**DEPARTMENT** Community Development PRESENTED BY

DATE December 20, 2022

Resolution 2022-62: A Resolution of the City Council for the City of Salida, Colorado Approving the Subdivision Plat for the Salida Crossings Major Subdivision (Public Hearing)

1     PER CITY COMMENTS     12/16/2022     JP       1     No.     RVISIONS     DATE     BY
ENGINE ERING
SCALE: SEE SHEET DESIGNED BY: JJP DRAWN BY: ZJD CHECKED BY: RR
FINAL PLAT
SALIDA CROSSINGS CITY OF SALIDA CHAFFEE COUNTY, CO
DATE 10/27/2022 PROJECT NO. 17202

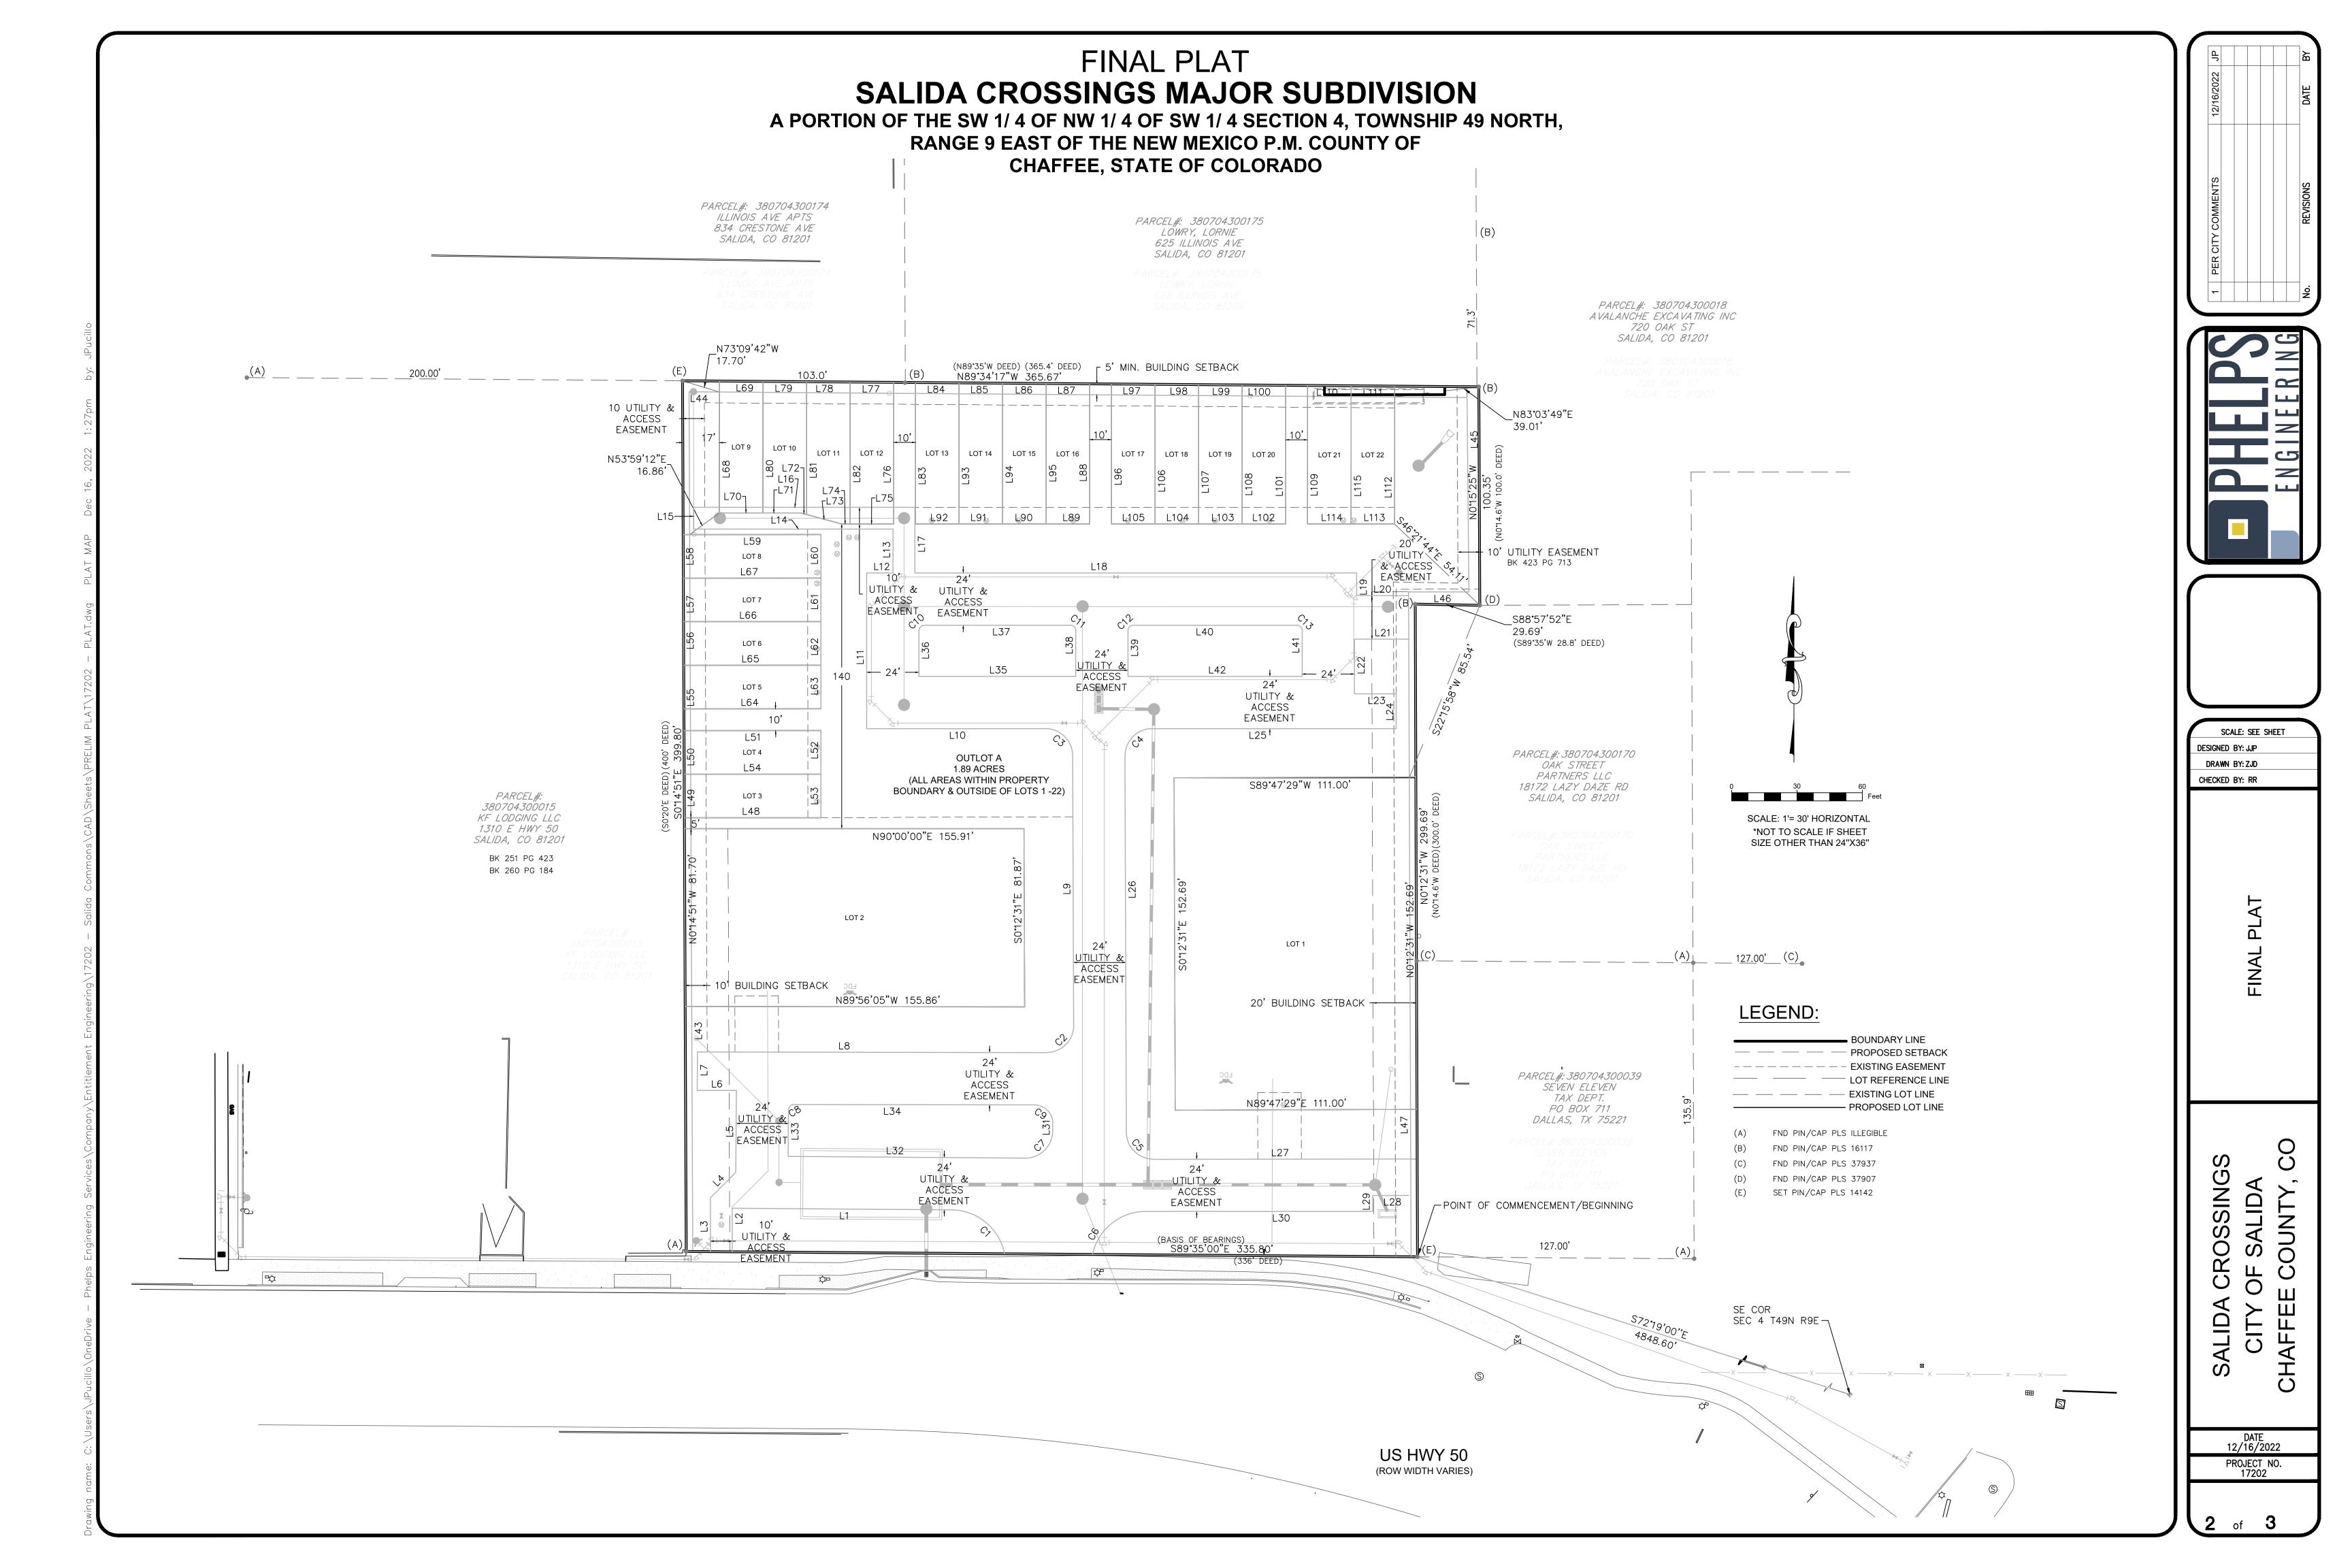
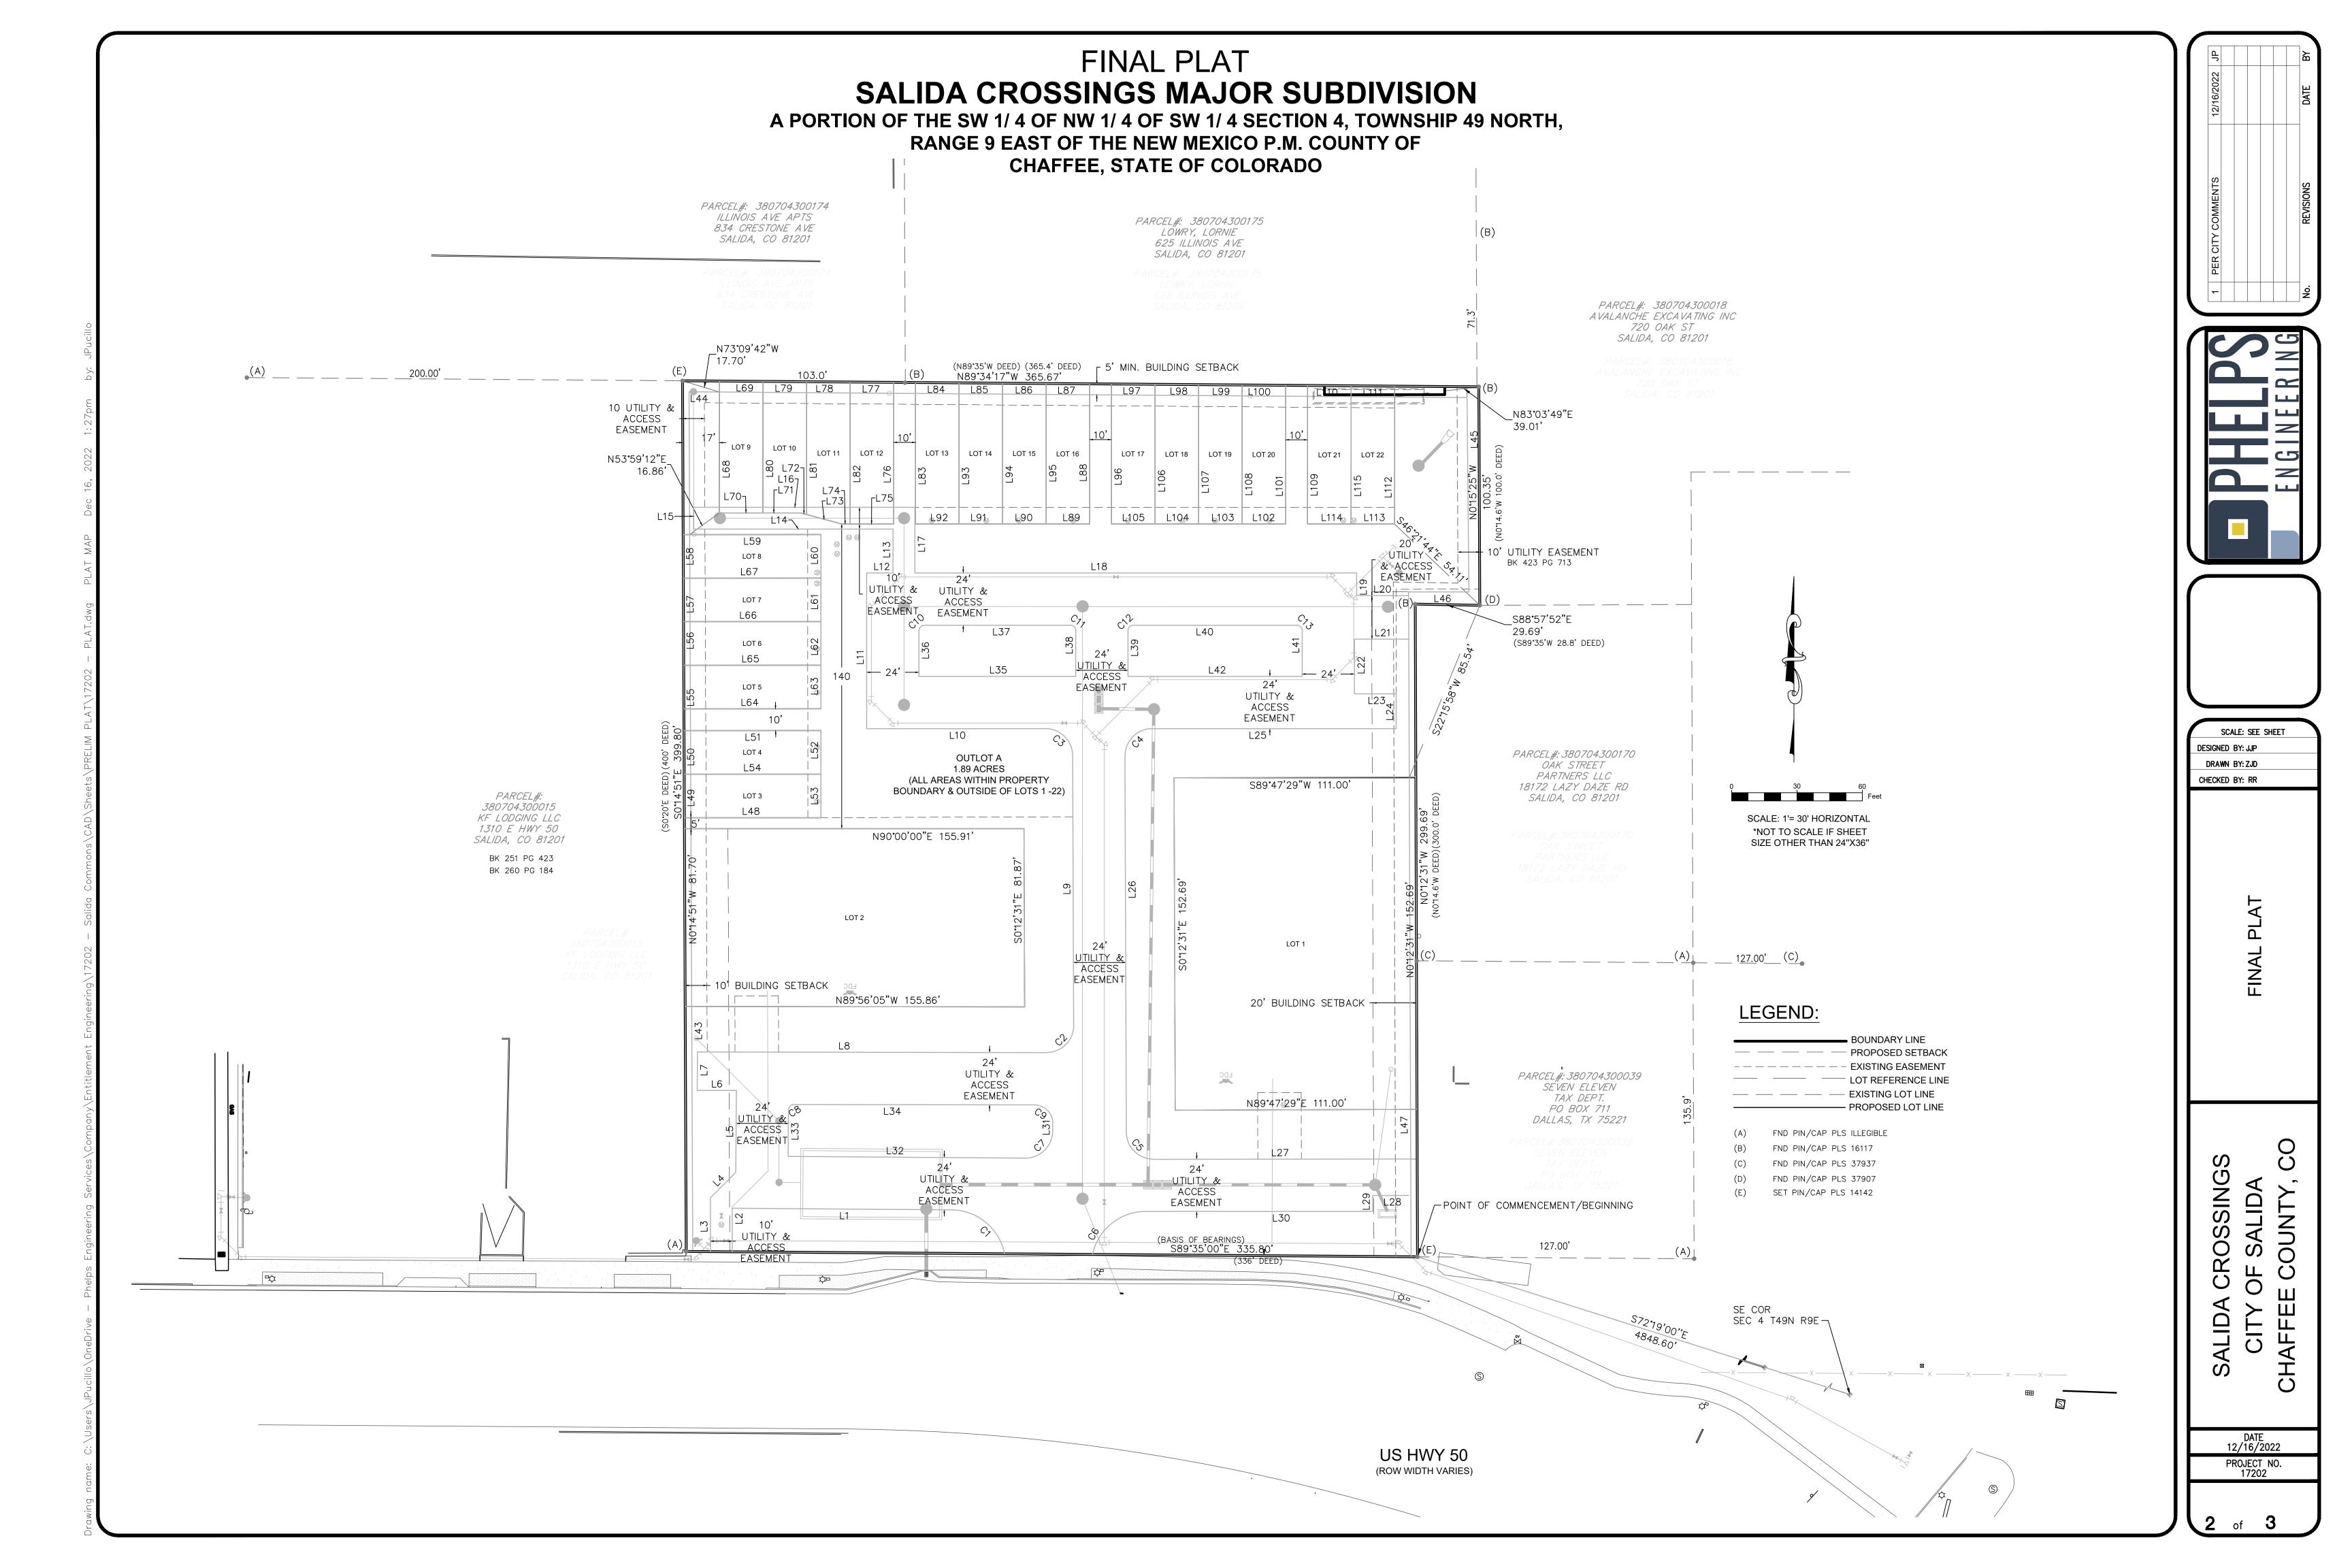
- The applicant may locate a portion of the required water line on the subject property, leaving a minimum of 5-foot clearance on either side of the line and shall dedicate a minimum 10-foot public utility easement (PUE) for access to said utilities on the plat.
- Private utility easements shall also be required per review and final approval of local utility providers and shown on the development plan and subdivision plat.

- A plat note shall be added that states "All required access permits from CDOT must be received and reviewed by staff prior to issuance of building permits."
- The developer shall enter into a Subdivision/Development Improvements Agreement to address the improvements required for the project as well as other conditions of approval, prior to issuance of a building permit.

2) Provide a plat for review with utility improvements overlay.

THE DEVELOPMENT WILL BE SUBJECT TO DIMENSIONAL STANDARDS AND ANY OTHER REQUIREMENTS OF THE APPROVED SALIDA CROSSINGS PLANNED DEVELOPMENT MODIFICATION.

DEVELOPER SHALL CONSTRUCT A LANDSCAPING STRIP (WHICH COULD INCLUDE A STORMWATER-DETAINING BIO-SWALE) FOR THE APPROXIMATELY 1-10 FEET OF ROW BETWEEN THE BACK OF THE EXISTING SIDEWALK AND THE SUBJECT PROPERTY, TO BE REVIEWED AND APPROVED BY STAFF, PRIOR TO ISSUANCE OF ANY CERTIFICATE OF OCCUPANCY FOR THE PROJECT. SUCH LANDSCAPE STRIP SHALL INCLUDE A MINIMUM OF SIX (6) TREES AND VARIOUS SHRUBBERY TO BE PLANTED AND EFFECTIVELY MAINTAINED BY THE DEVELOPER AND HOA. ALL REQUIRED TREES SHALL BE REPLACED UPON MORTALITY, UNLESS SPECIFICALLY AUTHORIZED BY STAFF.

NO SHORT-TERM VACATION RENTAL LICENSES SHALL BE PERMITTED IN THE DEVELOPMENT. 8. DEVELOPER SHALL PROVIDE A FLEXIBLE RECREATIONAL PLAYSCAPE OR SIMILAR AMENITIES TO ENCOURAGE PLAY AND OUTDOOR ACTIVITY FOR PEOPLE OF ALL AGES IN ONE OR MORE OF THE OPEN SPACE/LANDSCAPE AREAS ON THE SITE. THE FACILITY SHALL BE CONSTRUCTED PRIOR TO CO OF EITHER MIXED-USE BUILDING, AND ACCESS TO SAID AREA(S) SHALL BE PROVIDED VIA SIDEWALKS THAT WILL CONNECT THE MIXED-USE BUILDINGS AND THE TOWNHOMES. SECURITY FENCING IS ALSO RECOMMENDED FOR SAID AMENITIES.

THE APPLICANT SHALL PROVIDE, AT TIME OF BUILDING PERMITS, WITH ELEVATIONS SHOWING DISTINCT VARIATION BETWEEN THE FACADES OF EACH FOUR-PLEX BUILDING. SUCH VARIATION MAY BE PROVIDED VIA DIFFERENTIATED ROOF STYLES AND/OR PATIO AND DOOR AND SHALL BE APPROVED BY STAFF. THE DUPLEXES, GIVEN THEIR PHYSICAL SEPARATION FROM EACH OTHER, MAY MAINTAIN THE SAME ARCHITECTURAL STYLE, BUT BE DIFFERENTIATED FROM EACH ADJACENT FOUR-PLEX. THE DEVELOPER SHALL ALSO INCLUDE ARCHITECTURAL ELEMENTS ON WINDOWS AND DOORS OF THE MIXED-USE BUILDINGS, TO BREAK UP THE FAÇADE ELEVATIONS.

11. ALL REQUIRED ACCESS PERMITS FROM CDOT MUST BE RECEIVED AND REVIEWED BY STAFF PRIOR TO ISSUANCE OF BUILDING PERMITS. 12. THE DEVELOPER SHALL PROVIDE AMPLE BIKE PARKING (MINIMUM ONE SPACE PER UNIT, IN AN AREA WITH GOOD VISIBILITY
